Paragraph 6.1.6., the reference to "paragraph 1.42.", amend to read "paragraph 1.20."

Figure 1, amend to read :

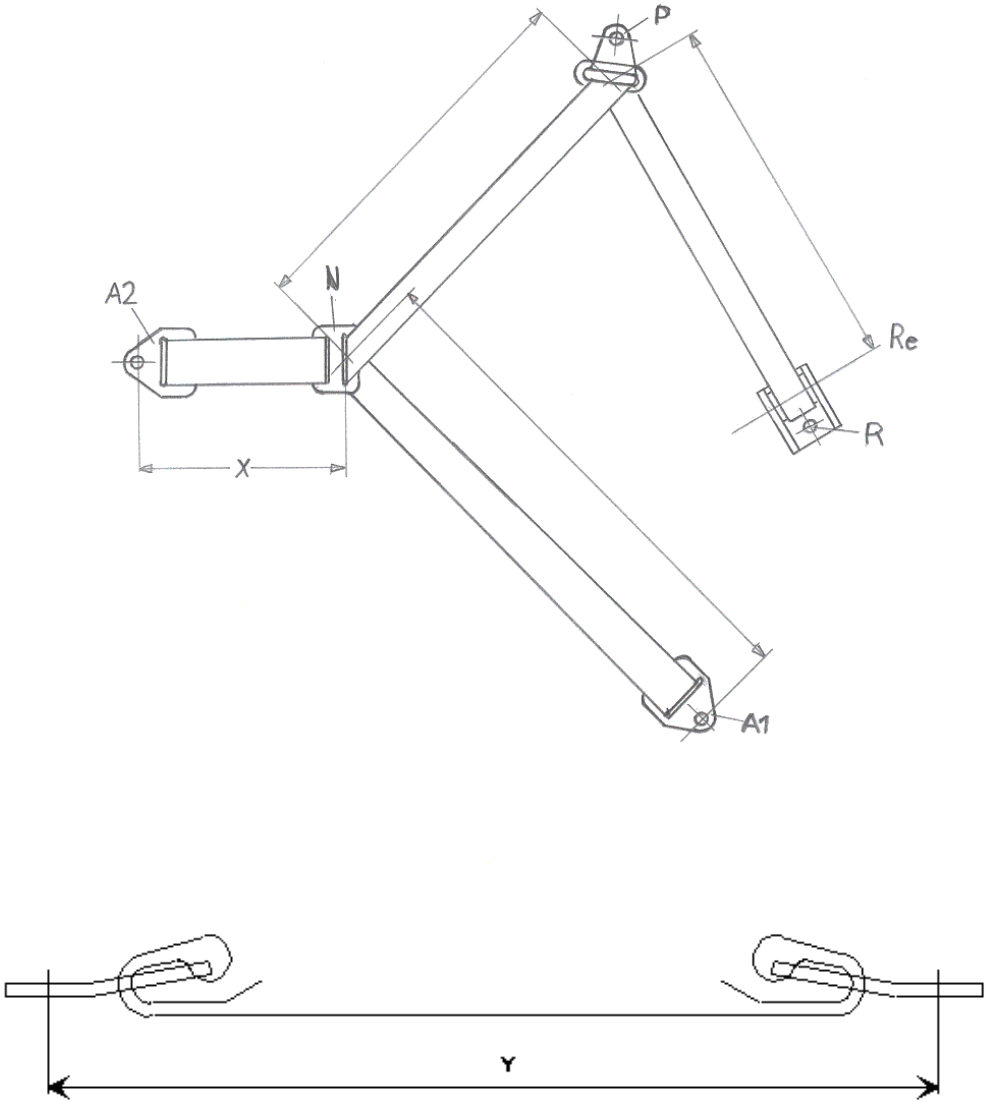
Paragraph 3., amend to read:

Belt retractor R shall be fitted to trolley anchorage such that the spool centre-line is positioned on Re

The value of X in Figure 1 below is 200 ± 5 mm. The **effective** strap length between A1 and the centre-line of the retractor spool Re (**when the webbing is fully extracted including the minimum length of 150 mm***) for testing of universal and semi-universal categories shall be 2820 ± 5 mm when measured in a straight line without load and on a horizontal surface; this length may be increased for testing of restricted category; for all categories with the child restraint installed there shall be a minimum of 150 mm* of strap length on the retractor spool."
